City of Keene Planning Board

AGENDA

Monday, December 20, 2021

SPR-897, MODIFICATION #1 — SITE PLAN REVIEW & SWP-CUP-2021-04 – SURFACE WATER PROTECTION CONDITIONAL USE PERMIT REVIEW – U-HAUL OF SOUTH KEENE – 472 WINCHESTER STREET & 0 KRIF ROAD

Figure 1. Excerpt of the "Truck Turning Exhibit" plan submitted by the Applicant to show truck turning movements into the site using the easternmost curb cut on Krif Road.

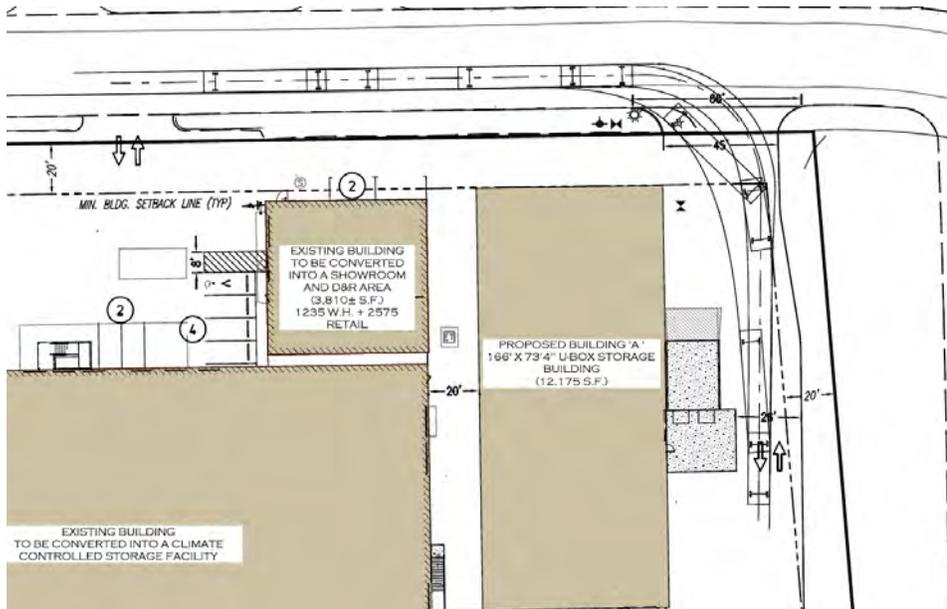
The Applicant has submitted a request for an exception from Section 22.5.4.9 of the Land Development Code to permit a driveway that is 45 ft at the property line and 66 ft at the curbline. In order demonstrate the need for this additional width, a truck turning template was submitted to show truck turning movements from Krif Road into the site (see Figure 1).

Figure 3. Image submitted by the Applicant to show the portion of the gravel driveway that would be temporary (shaded blue) and the portion that is proposed to be permanent (shaded in green).

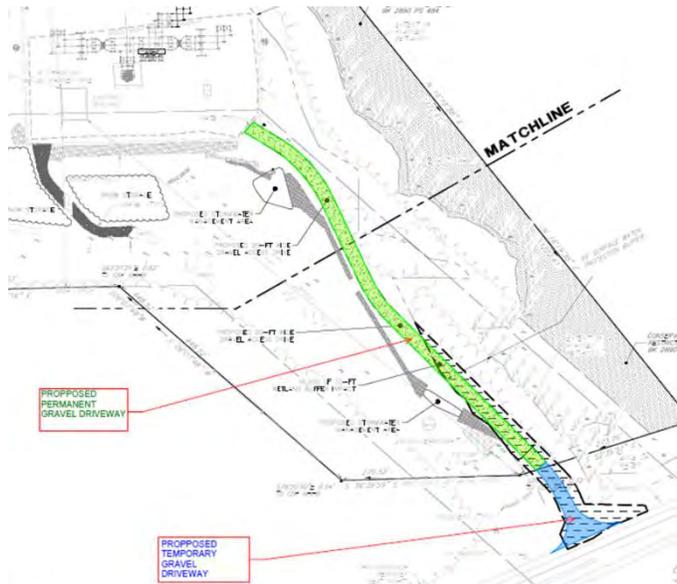
20.9 Traffic & Access Management: No changes are proposed to the permanent access points to this site; however, the Applicant does propose to reconstruct a gravel driveway with access from NH Route 12. In order to avoid the need for reconstructing this driveway again in the future, the Applicant proposes to make the portion of the driveway located on the 115 Park Ave. property a permanent feature of the site (see area shaded green in Figure 3). The portion of the driveway within the NHDOT controlled access right-of-way would be temporary and will be removed after construction is completed (see area shaded blue in Figure 3).
